MODIFICATION RECOMMENDED –
CORRECTS MANUFACTURING OR DESIGN DEFECTS

E5071A-05B

S E R V I C E N O T E

E5071A ENA Series Network Analyzer, 300 kHz to 8.5 GHz

Figure 1. Trace shows noise around 1.3 GHz to 2.1 GHz at preset setting.

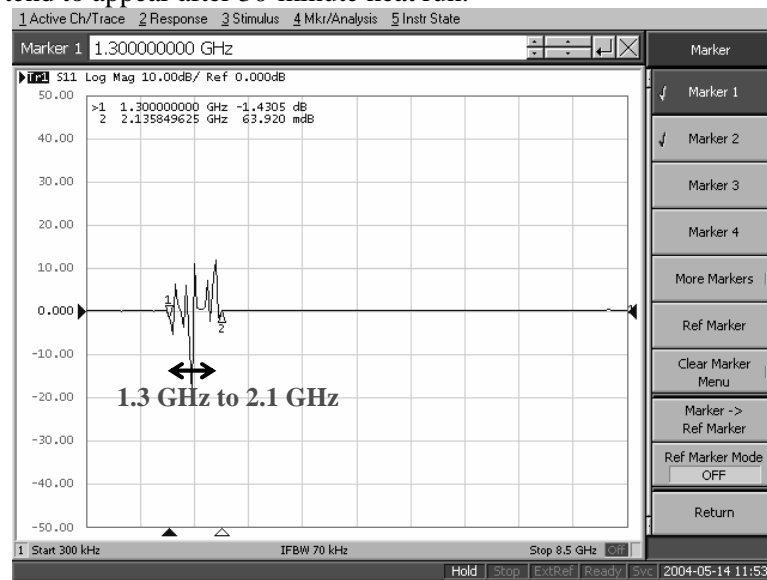
When the high-failure rate part has defective, the unit cannot output correct power level source or local signal, between 1.3 GHz and 2.1 GHz frequency range.

- The trace shows spike at 1.3 GHz or 2.1 GHz at the preset situation.
- The trace between 1.3 GHz to 2.1 GHz is more noisy than other frequency ranges.
- The power level of 1.3 GHz to 2.1 GHz is lower than other frequency ranges.
- Internal test of A1 ALC shows fail at SOP (f=1.3G) or LOP (f=1.3G) as Figure 2.

Above symptoms tend to appear after 30-minute heat run.

When a measurement trace or output power shows troubles between 1.3 GHz and 2.1 GHz, or in full frequency range, replace A1 module with the latest one (E5071-6x571), and update E5071A Operating System at the same time.
